AGENDA
CITY OF LAKE WORTH BEACH
HISTORIC RESOURCES PRESERVATION BOARD REGULAR MEETING
CITY HALL COMMISSION CHAMBER
WEDNESDAY, JULY 12, 2023 -- 6:00 PM

FROM: Anne Greening, Senior Preservation Planner
 Yeneneh Terefe, Preservation Planner
 Department for Community Sustainability

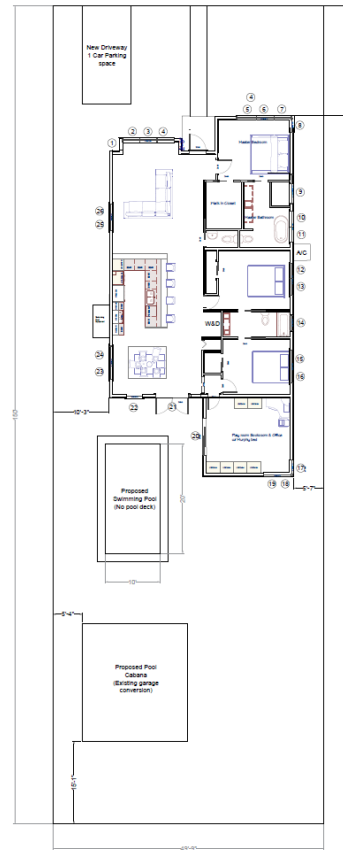
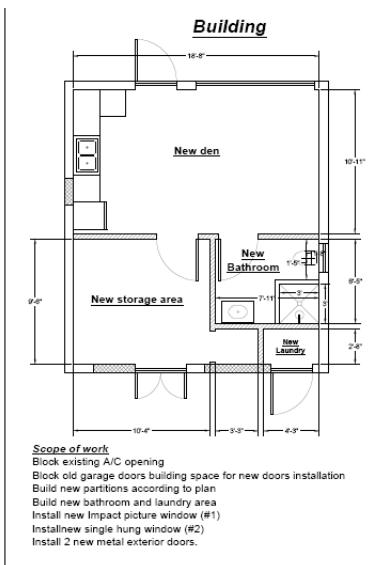
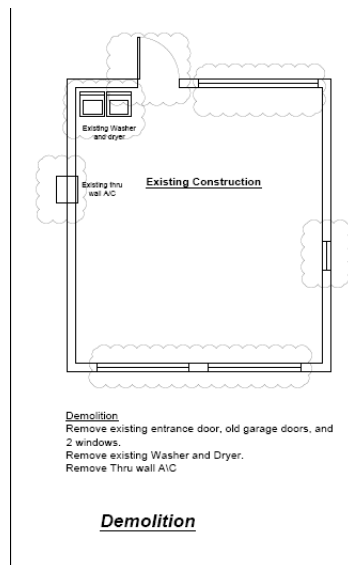
- Cabana: No, the proposed filling in of the original garage door openings is not appropriate according to the Historic Preservation Design Guidelines. In general, all windows and doors are should be installed in their existing openings; the Design Guidelines discourage filling in existing openings to accommodate alternately sized products. The proposed alterations will not imitate the appearance of a garage, nor will they leave a recessed area to exemplify the historic function of the space.

- Addition: No, the front addition is not visually compatible with the neighboring properties since it will remove and alter the primary façade of the historic structure. Furthermore, the proposed front addition will interrupt the rhythm and consistency of the neighborhood by altering the front setback at 1405 South Palmway. The west side of the 1400 block of South Palmway has a consistent front setback amongst all the houses; the proposed front addition would make 1405 South Palmway's front façade closer to the street than the rest of the houses on the block.
- Cabana: Not applicable. The accessory structure is not visible from a public right-of-way.
